REMARKS/ARGUMENTS

[2] Remarks for Amendment to Drawings 4-7:

Amendment to the Drawings:

4 Fino

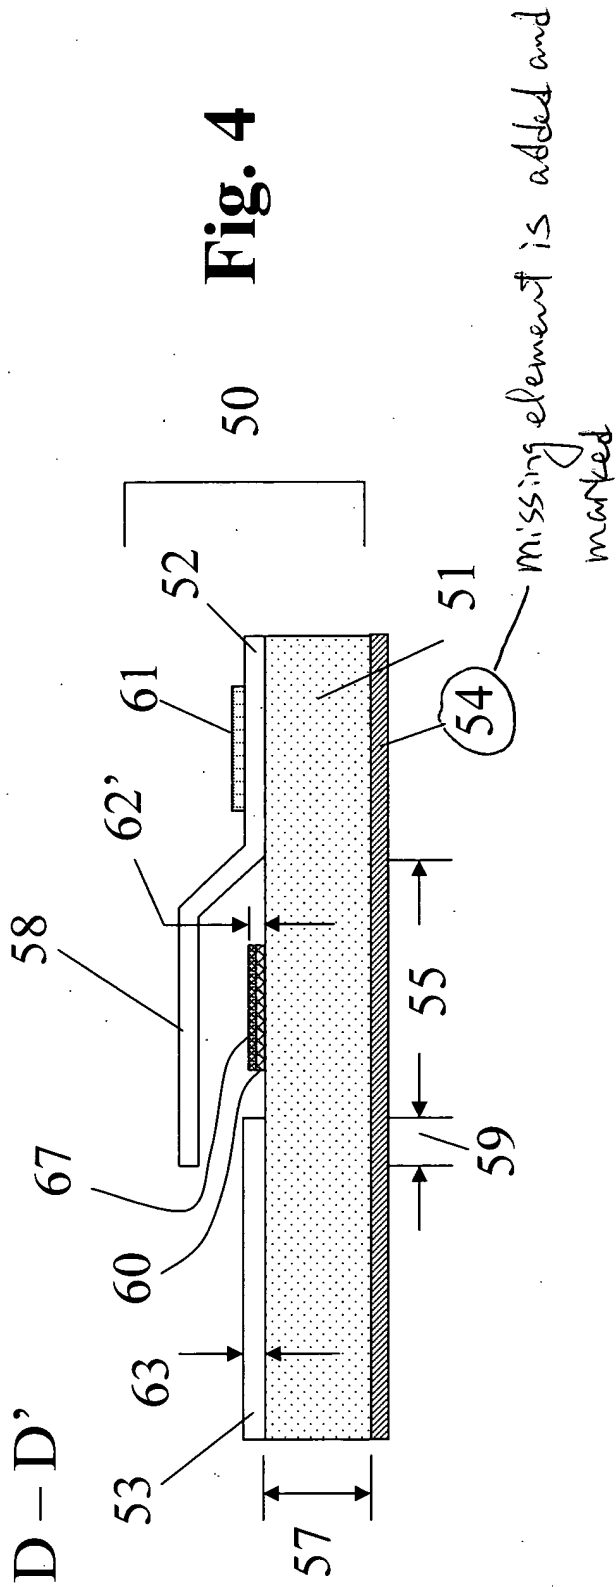
In amended Figs. 4, 5 and 7(b), the previously omitted element number (54) has been added and marked.

missing element is added and marked

Fig 5

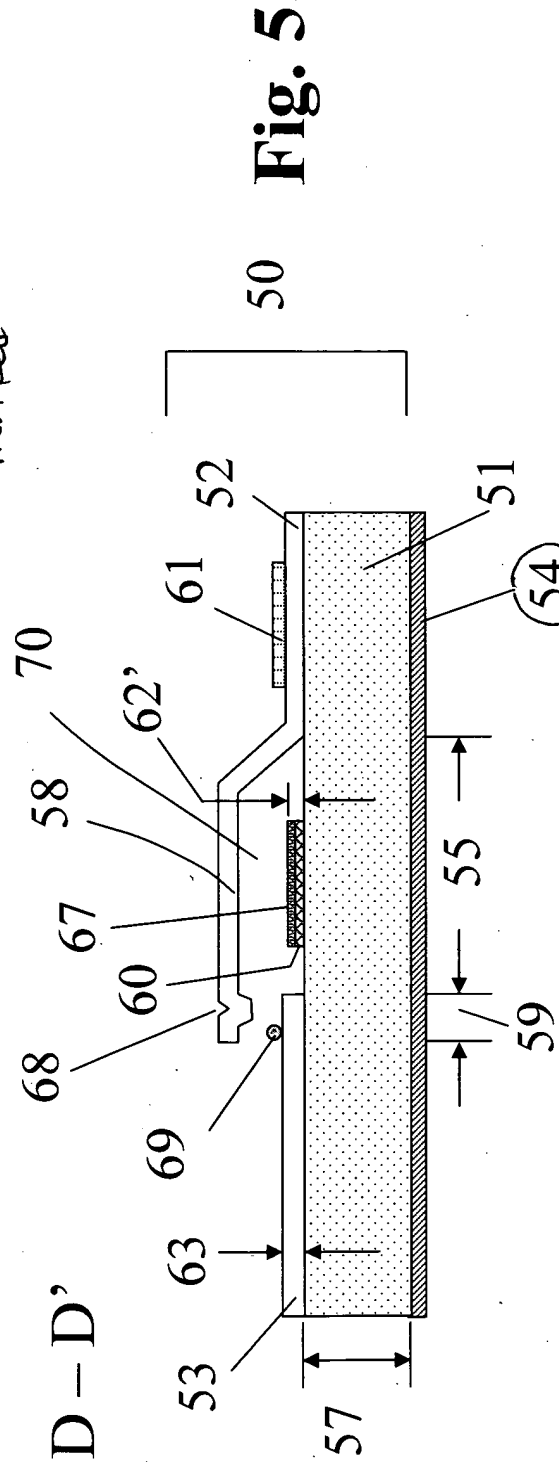
Missing element is added and marked
